1CAN100901

SUBJECT: Response to Request for Additional Information on the
Third 10-Year Inservice Inspection Interval
Requests for Relief
Arkansas Nuclear One, Unit 1
Docket No. 50-313
License No. DPR-51

**Responses to NRC's RAIs on Third 10-Year
Inservice Inspection Interval Requests for Relief**

Scanning Limitations for Welds 01-005 and 01-006

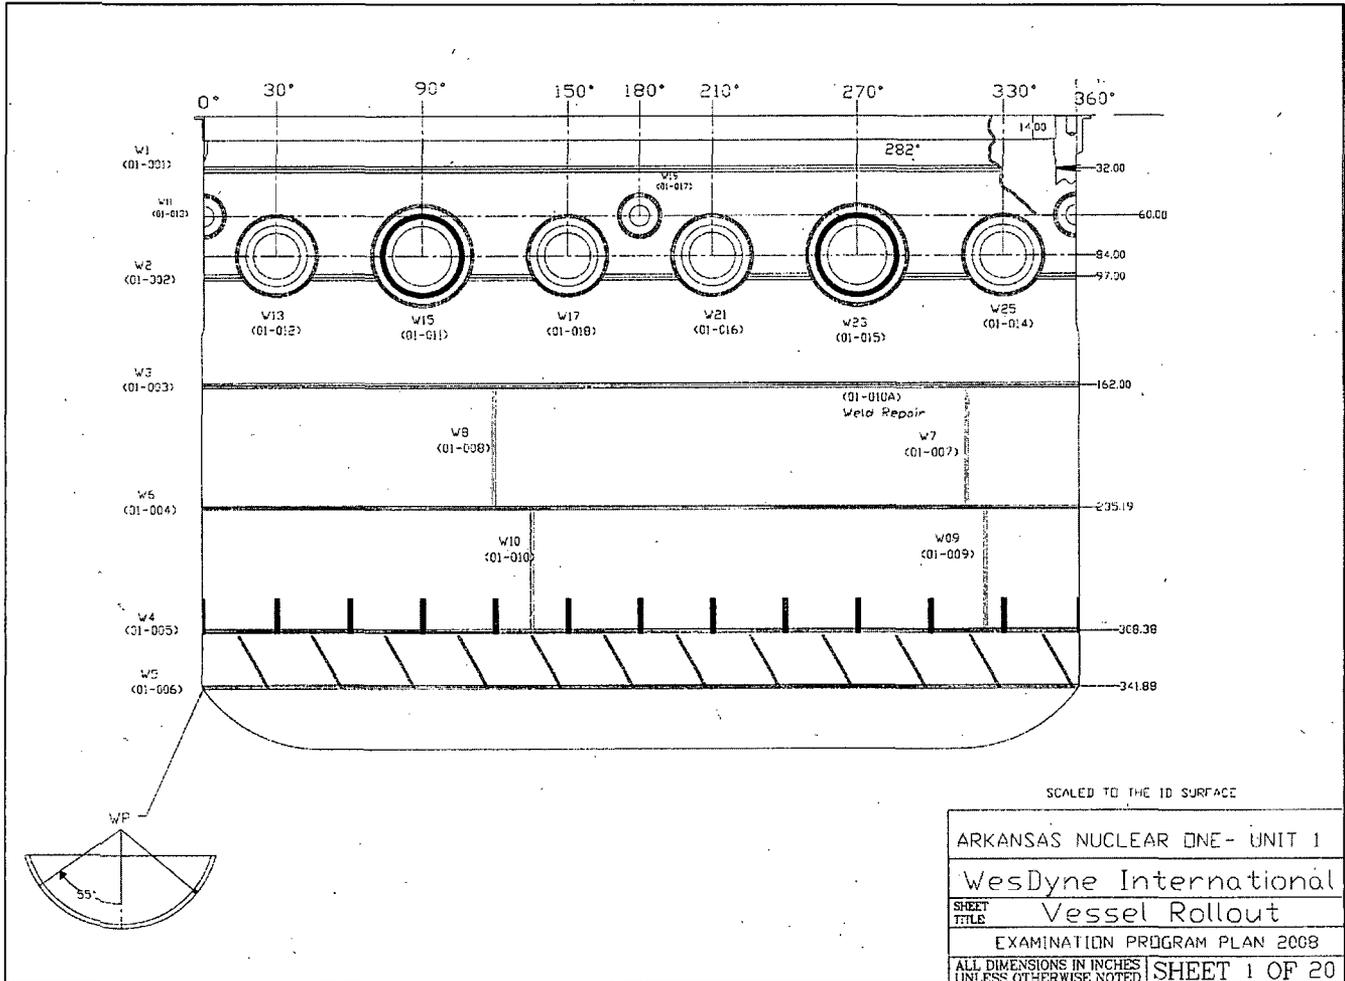
Request for Relief ANO1-ISI-015					
Limited B-A Examinations					
Item Number	Comp. ID	Item Description	% Coverage	Reason for Limitation	Response to NRC Request for Additional Information
B1.11	01-005	Lower Shell to Lower Reactor Pressure Vessel (RPV) Head Weld	App. VIII 36.38%	This examination is performed from the interior of the RPV. Coverage is physically limited due to the core support lugs and flow diverters attached to the RPV.	<p>a) See attached sketches derived from WesDyne examination program plan 2008 (sheets 1 and 8 of 20) on file at ANO.</p> <p>b) Automated ultrasonic testing (UT) examination performed by WesDyne International, utilizing an eight (8) transducer sled measuring 5.38" wide, 9.51" in length.</p> <p>Thirteen (13) core stop lugs and twelve (12) flow diverters precluded coverage of the full weld volume. See attached sketch.</p> <p>As stated in Section III of the request for relief, there are no alternative methods or advanced technologies which could be reasonably employed to maximize ASME Code coverage.</p> <p>c) Wave modality used include shear and refracted longitudinal.</p> <p>Insonification angles employed included a 45° shear and a 45° refracted longitudinal.</p> <p>For additional coverage, the transducer sled was rotated for both parallel and perpendicular scans beneath the core stop lugs.</p>

<p>d) See attached sketch derived from WesDyne examination program plan 2008 (sheets 1 and 8 of 20) on file at ANO.</p> <p>e) Surface examination was not required.</p> <p>f) No indications were reported as a result of Code-required examinations.</p>
B1.21	01-006	Bottom RPV Head Weld	App. VIII 59.07%	<p>This examination is performed from the interior of the RPV. Coverage is physically limited due to the location of the twelve (12) flow diverters attached to the bottom head.</p>	<p>a) See attached sketches derived from WesDyne examination program plan 2008 (sheets 1 and 9 of 20) on file at ANO.</p> <p>b) Automated UT examination performed by WesDyne International, utilizing an eight (8) transducer sled measuring 5.38" wide, 9.51" in length.</p> <p>Twelve (12) flow diverters precluded coverage of the full weld volume. See attached sketch.</p> <p>As stated in Section III of the request for relief, there are no alternative methods or advanced technologies which could be reasonably employed to maximize ASME Code coverage.</p> <p>c) Wave modality used include shear and refracted longitudinal.</p> <p>Insonification angles employed included a 45° Shear and a 45° refracted longitudinal.</p> <p>For additional coverage, the transducer sled was rotated were possible.</p>

Scanning Limitations for Welds 05-014 and 05-015

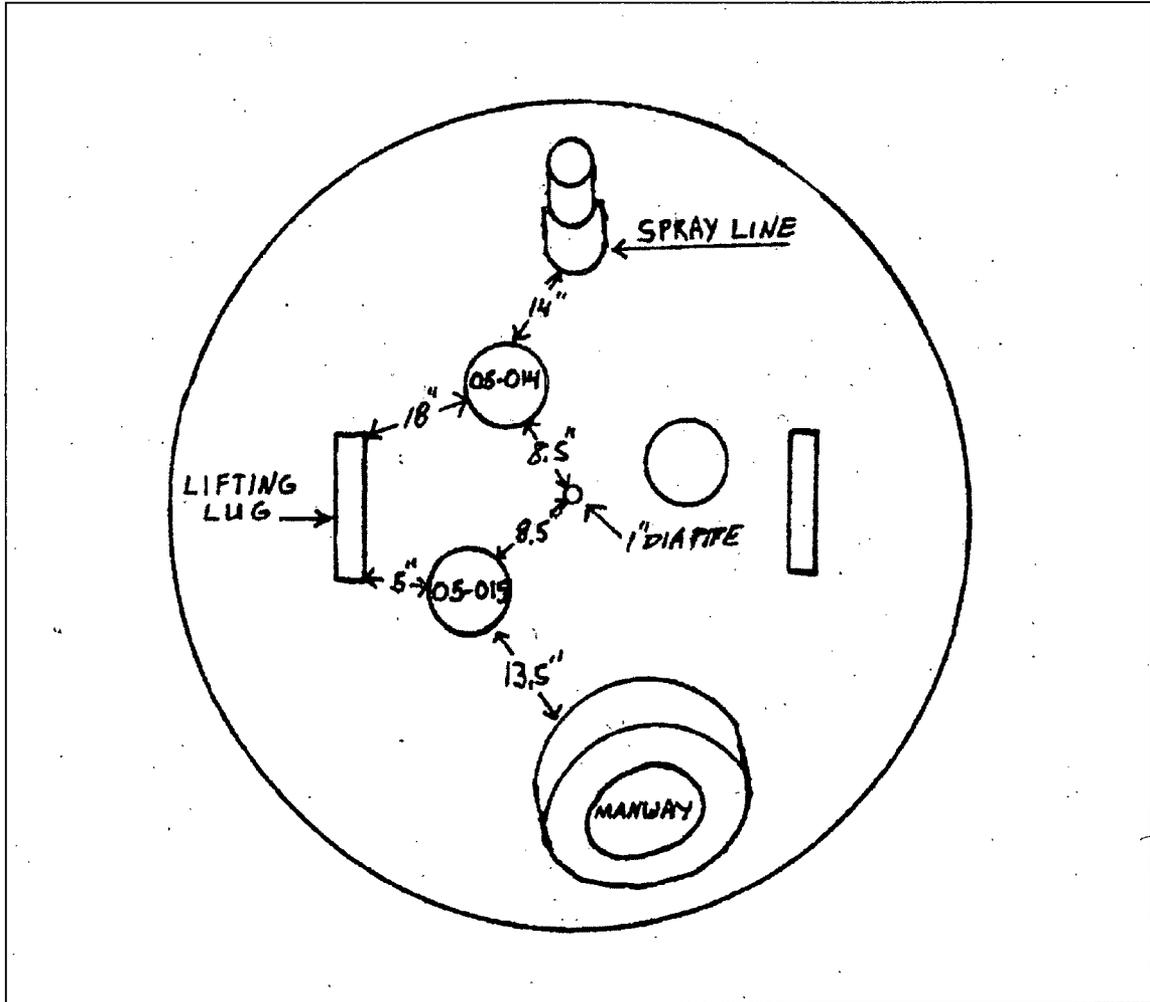
Request for Relief ANO1-ISI-016					
Limited B-D Examinations					
Item Number	Comp. ID	Item Description	% Coverage	Reason for Limitation	Response to NRC Request for Additional Information
B3.110	05-014	Pressurizer (PZR) Relief Nozzle-to-Head Circumferential (Circ) Weld	28.7%	This is essentially a single sided exam due to the component configuration. Scan paths were also limited due to close proximity of adjacent nozzles and welded lifting lugs as well as the curvature of the PZR head.	<p>a) See attached sketches derived from UT examination report 102ISIUT011 on file at ANO.</p> <p>b) Manual UT examination.</p> <p>A detailed sketch of the limitations and their proximity to the component are attached.</p> <p>c) Wave modality used included shear and longitudinal.</p> <p>Insonification angles included 0°, 45°, 60°, and 70°.</p> <p>d) See attached sketches derived from UT examination report 102ISIUT011 on file at ANO.</p> <p>e) Surface examination was not required.</p> <p>f) Intermittent geometric indications from the nozzle bore were observed.</p>

B3.110	05-015	PZR Relief Nozzle-to-Head Circ Weld	28.7%	This is essentially a single sided exam due to the component configuration. Scan paths were also limited due to the close proximity of adjacent	<p>a) See the attached sketches derived from UT examination report 102ISIUT024 on file at ANO.</p> <p>b) Manual UT examination.</p> <p>A detailed sketch of the limitations and their</p>

nozzles and welded lifting lugs.	<p>proximity to the component are attached.</p> <p>c) Wave modality used included shear and longitudinal.</p> <p>Insonification angles included 0°, 45°, 60°, and 70°.</p> <p>d) See attached sketches derived from UT examination report 102ISIUT024 on file at ANO.</p> <p>e) Surface examination was not required.</p> <p>f) Intermittent geometric indications from the nozzle bore were observed.</p>
B3.110	05-021	PZR Surge Nozzle-to-Head Circ Weld	32%	This is essentially a single sided exam due to the component configuration. Scan paths were also limited due to the close proximity of adjacent nozzles and welded lifting lugs.	<p>a) See the attached sketches derived from UT examination report ISI-UT-07-027 on file at ANO.</p> <p>b) Manual UT examination.</p> <p>A detailed sketch of the limitations and their proximity to the ISI component are attached.</p> <p>c) Wave modality used included shear and longitudinal.</p> <p>Insonification angles included 0°, 45°, 60°, and 70°.</p> <p>d) See attached sketches derived from UT examination report ISI-UT-07-027 on file at ANO.</p>

Coverage Plot for Weld 09-001

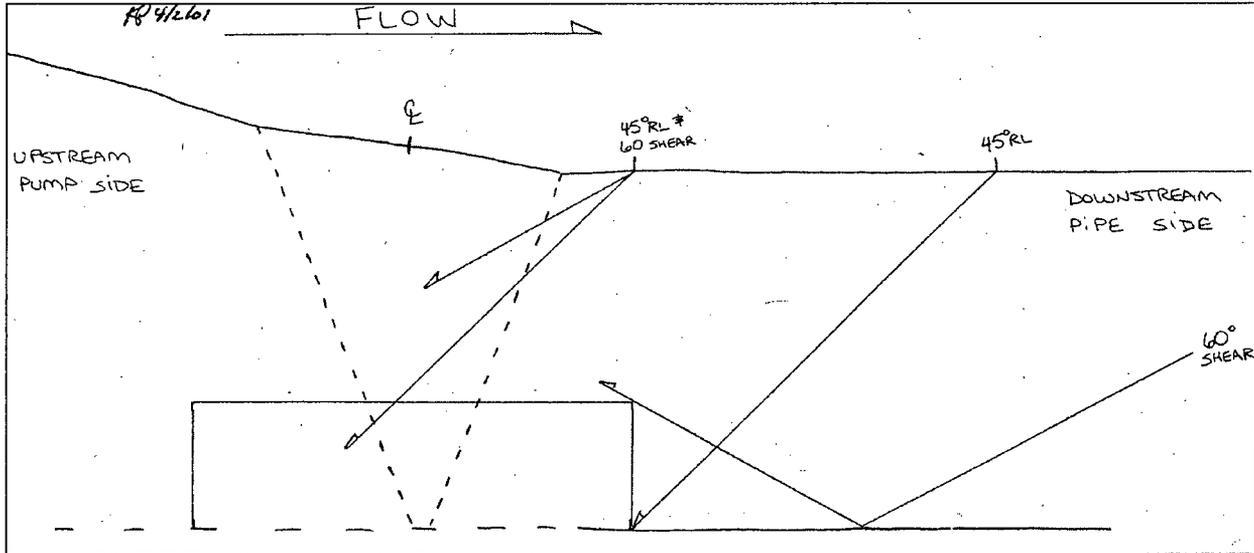
Request for Relief ANO1-ISI-018					
Limited B-J Examinations					
Item Number	Comp. ID	Item Description	% Coverage	Reason for Limitation	Response to NRC Request for Additional Information
B9.11	09-001	"D" Reactor Coolant Pump (RCP) Pump to Pipe Circ Weld	50.0%	This is a single sided examination from the pipe side only of the pump to 28" pipe configuration.	<p>a) See attached sketch derived from NDE report 101ISIUT037 on file at ANO.</p> <p>b) Manual UT examination.</p> <p>A detailed sketch of the scanning restriction is attached.</p> <p>c) Wave modality used included shear and refracted longitudinal.</p> <p>Insonification angles included 45° and 60°.</p> <p>d) See attached sketch derived from NDE report 101ISIUT037 on file at ANO.</p> <p>e) Surface examination was not required.</p> <p>f) No indications were reported as a result of Code required examinations.</p>
B9.32	09-006	Pipe-to-High Pressure Injection (HPI) Nozzle Circ Weld	50%	This is a single sided examination from the pipe side only of the 6" nozzle to 28" pipe configuration	<p>a) See attached sketch derived from NDE report 101ISIUT038 on file at ANO.</p> <p>b) Manual UT examination.</p> <p>A detailed sketch of the scanning restriction is</p>

<p>attached.</p> <p>c) Wave modality used included shear and refracted longitudinal.</p> <p>Insonification angles included 45°.</p> <p>d) See attached sketch derived from NDE report 101ISIUT038 on file at ANO.</p> <p>e) Surface examination was not required.</p> <p>f) No indications were reported as a result of Code-required examinations.</p>
B9.21	18-010	PZR Spray Valve-to-Pipe Circ Weld	50%	This is a single sided examination from the pipe side only of the 2.5" valve to 2.5" pipe configuration	<p>a) See attached sketch derived from NDE report ISI-UT-07-014 on file at ANO.</p> <p>b) Manual UT examination.</p> <p>A detailed sketch of the scanning restriction is attached.</p> <p>c) Wave modality is shear.</p> <p>Insonification angles included 45°, 60°, and 70°.</p> <p>d) See attached sketch derived from NDE report ISI-UT-07-014 on file at ANO.</p> <p>e) Surface examination was not required.</p> <p>f) One indication was recorded with the 70° shear and dispositioned as a geometric reflector.</p>

Coverage Plot for Weld 23-055

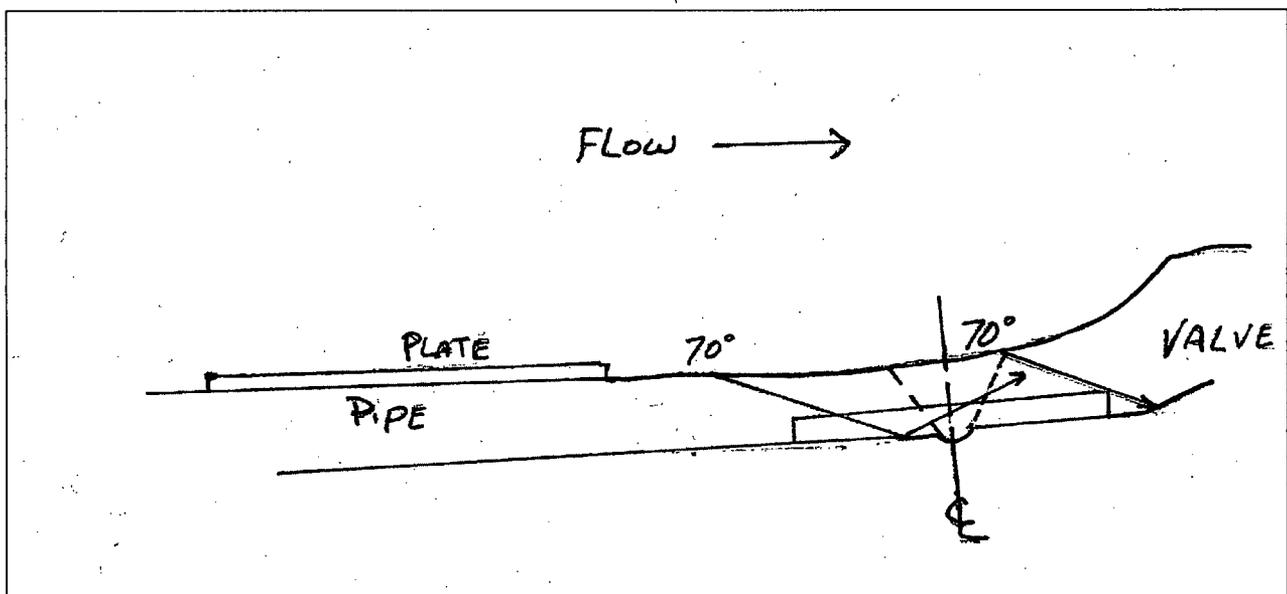
B9.21	23-055	HPI to B2 Loop Elbow- to-Valve Circ Weld	41%	<p>This is a single sided examination from the pipe side only of the 2.5" pipe to valve configuration. The exam is further limited due to a welded name tag on the pipe for ~ 180° around the circumference.</p>	<p>a) See attached sketch derived from NDE report ISI-UT-05-088 on file at ANO.</p> <p>b) Manual UT examination.</p> <p>A detailed sketch of the scanning restriction is attached. The position of the weld tag limits the axial movement of the transducer for ~ 180° around the circumference of the pipe allowing just 16% coverage in that area.</p> <p>c) Wave modality is shear.</p> <p>Insonification angle used is a 70°.</p> <p>d) See attached sketch derived from NDE report ISI-UT-05-088 on file at ANO.</p> <p>e) Surface examination was not required.</p> <p>f) No indications were reported as a result of Code-required examination.</p>

Limitation Sketch for Weld 22-099W

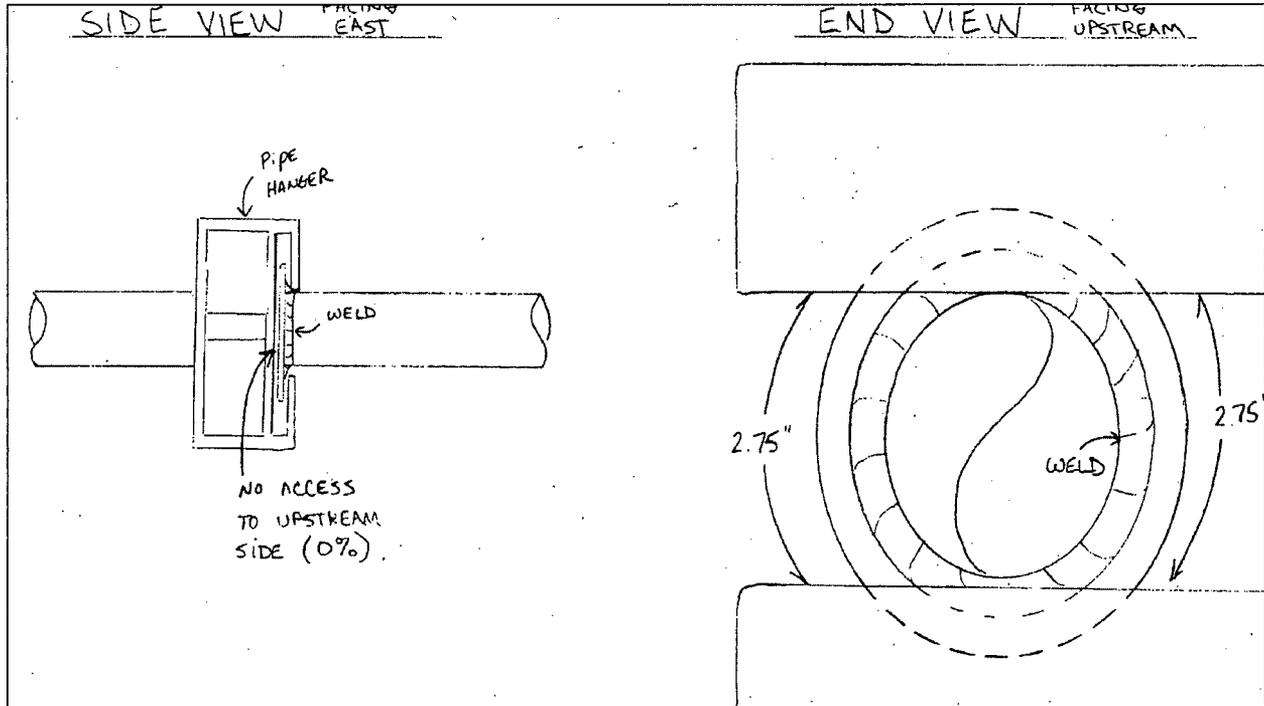
Request for Relief ANO1-ISI-019					
Limited B-K-1 Examinations					
Item Number	Comp. ID	Item Description	% Coverage	Reason for Limitation	Response to NRC Request for Additional Information
B10.20	22-099W	Pipe Support Integral Attachment Weld	38.5%	The examination area on the restraint was limited due to the configuration of the hanger.	<p>a) See attached sketch derived from NDE report 101ISIPT019 on file at ANO.</p> <p>b) A liquid penetrate surface examination was performed.</p> <p>There was no alternative methods or advanced technologies which could be employed to maximize ASME Code coverage.</p> <p>c) Not applicable.</p> <p>d) See attached sketch derived from NDE report 101ISIPT019 on file at ANO.</p> <p>e) A liquid penetrate surface examination was performed per Section XI requirements.</p> <p>f) No indications were discovered as a result of Code-required examinations.</p>
